# UNITED STATES PATENT AND TRADEMARK OFFICE

APPLICATION NO.	FILING DATE	FIRST NAMED INVENTOR	ATTORNEY DOCKET NO.	CONFIRMATION NO.
10/065,596	11/01/2002	Zhihong Ye	RD-29,357-1	2441

<b>Office Action Summary</b>	<b>Application No.</b> 10/065,596	<b>Applicant(s)</b> YE ET AL.	
	<b>Examiner</b> Julio C. Gonzalez	<b>Art Unit</b> 2834

## DETAILED ACTION

Fig. 1

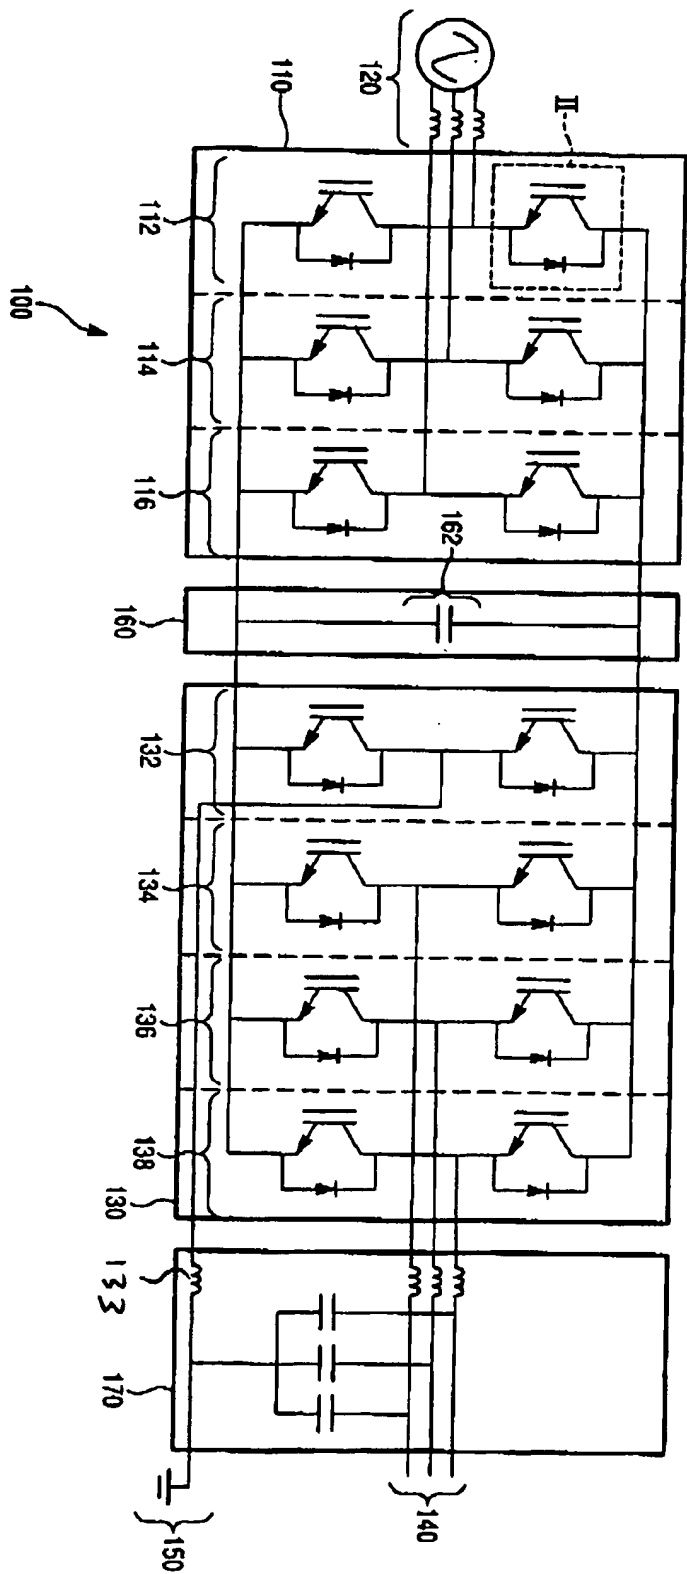
- 9) ☐ The specification is objected to by the Examiner.
- 10) ☒ The drawing(s) filed on 06 December 2005 is/are: a) ☒ accepted or b) ☐ objected to by the Examiner.  
Applicant may not request that any objection to the drawing(s) be held in abeyance. See 37 CFR 1.85(a).  
Replacement drawing sheet(s) including the correction is required if the drawing(s) is objected to. See 37 CFR 1.121(d).
- 11) ☐ The oath or declaration is objected to by the Examiner. Note the attached Office Action or form PTO-152.

Approved  
12/12/05
